20 January 2023

**RE: Planning Proposal to Rezone and Amend Minimum Lot Size on Lots at 48 Mountain Ash Rd & 292 Rosemont Rd Planning Proposal (REZ\_0006\_2121) (PP-2022-1180)**

## **ATTACHMENT 1 – DETAIL**

**Map 1.** Strategic Land and Water Capability Assessment for unsewered residential lots (4000 sqm – 2 ha) for land at 48 Mountain Ash Road and 292 Rosemont Road, Goulburn.

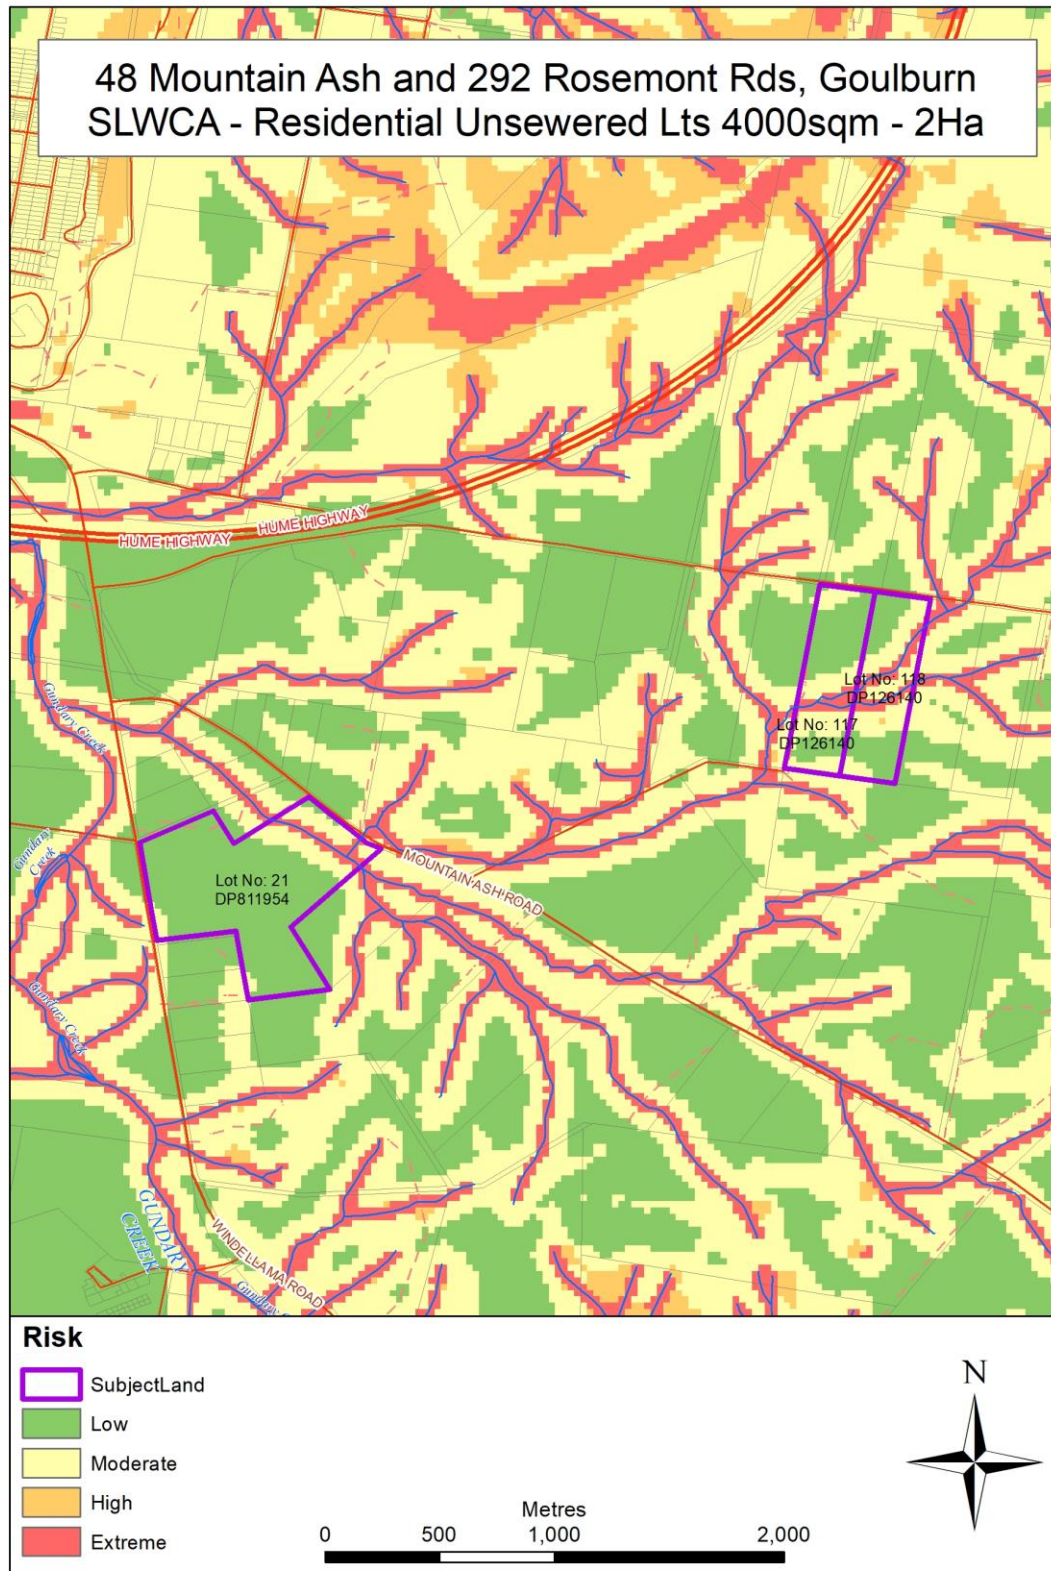
WaterNSW has prepared a SLWCA for the two sites. The most applicable SLWCA is unsewered residential lots (4,000 sqm – 2 ha) (see Map 1 in Attachment 2). The SLWCA shows that the water quality risk for each of the sites varies from LOW to EXTREME, with the areas of EXTREME risk being associated with the watercourses. Areas of EXTREME risk have a VERY LOW capability for unsewered residential development. The areas of EXTREME risk generally accord with the location of the proposed C2 zoning, thereby quarantining these areas from unsewered rural residential and ancillary development. We agree with this approach.

The remaining land areas carry either a LOW or MODERATE risk to water quality. Areas of LOW risk have a HIGH capability for development while areas of MODERATE risk have a MODERATE capability for unsewered development, respectively. Most of the Windellama site has a LOW risk while the remaining land areas in the Rosemont site have a LOW and MODERATE risk.

Having regard to the configuration of the risk categories on each of the sites, it is apparent that the Windellama site has a large contiguous land area of LOW risk that may be capable of sustaining unsewered rural residential development within the proposed R5 zone. However, the SLWCAs are not based on flooding risk. As identified elsewhere, parts of the Windellama site are affected by flooding under a PMF scenario which requires separate consideration (see earlier comments).
